**Date:** March 4, 2021  
**To:** Design Review Board  
**From:** Tony Leavitt, Senior Planner  
**File No.:** DRV20-00118  
**Subject:** **SALU PROJECT MODIFICATION TO DRB DECISION**

**FILE NUMBER:** DRV20-00118  
**PROJECT NAME:** EMERALD MIXED-USE PROJECT  
**APPLICANT:** MAIN STREET PROPERTY GROUP LLC  
**PROJECT PLANNER:** TONY LEAVITT, SENIOR PLANNER

## **SALU MODIFICATIONS**

PROPOSED - LEVEL 2 COURTYARD LOOKING EAST

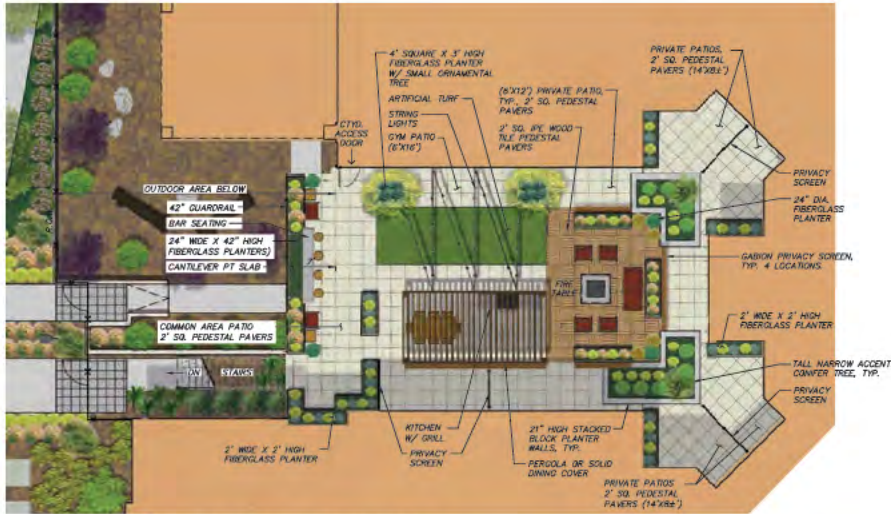
1. The applicant has eliminated the commercial use on the property. The project is now completely residential. As a result, the central courtyard has been relocated to the ground level and is directly accessible from the 116<sup>th</sup> Avenue sidewalk. The fence around the courtyard has been removed and the main entry to the project including lobby and leasing functions are now located on the north side of the courtyard.

PROPOSED - ROOF AMENITY PLAN  
SCALE: 1/16" = 1'-0"

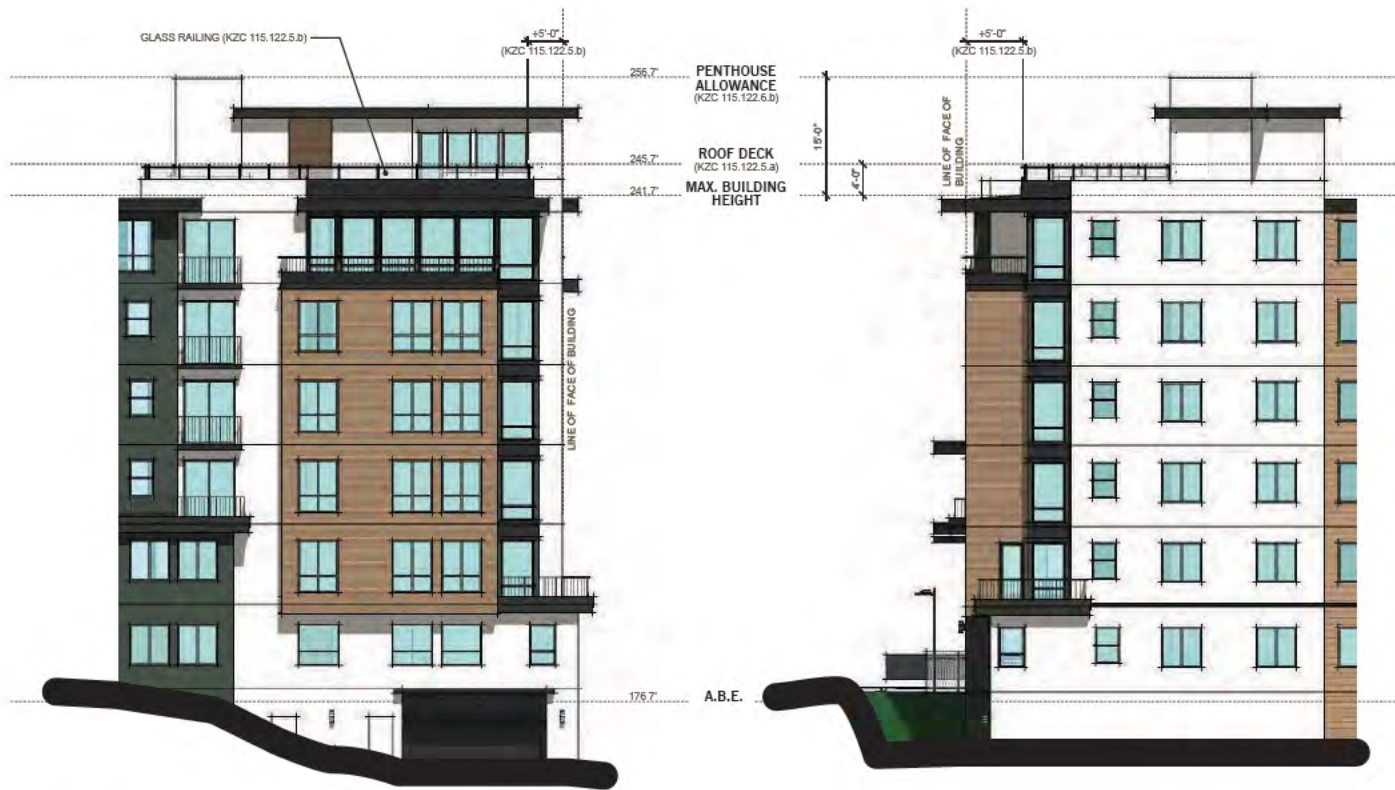
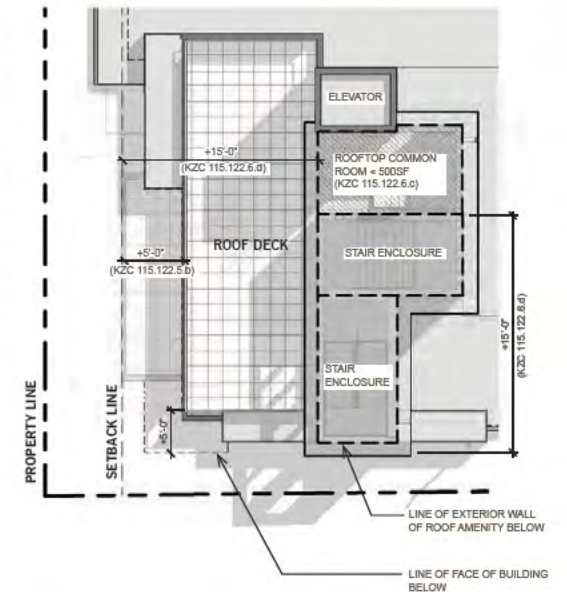
4. The trash pickup area has been relocated from the southwest corner of the project to the northern side to make pick-up easier.
5. As a result of recent zoning code amendments, the project now includes a rooftop amenity room and deck in the southwest corner.
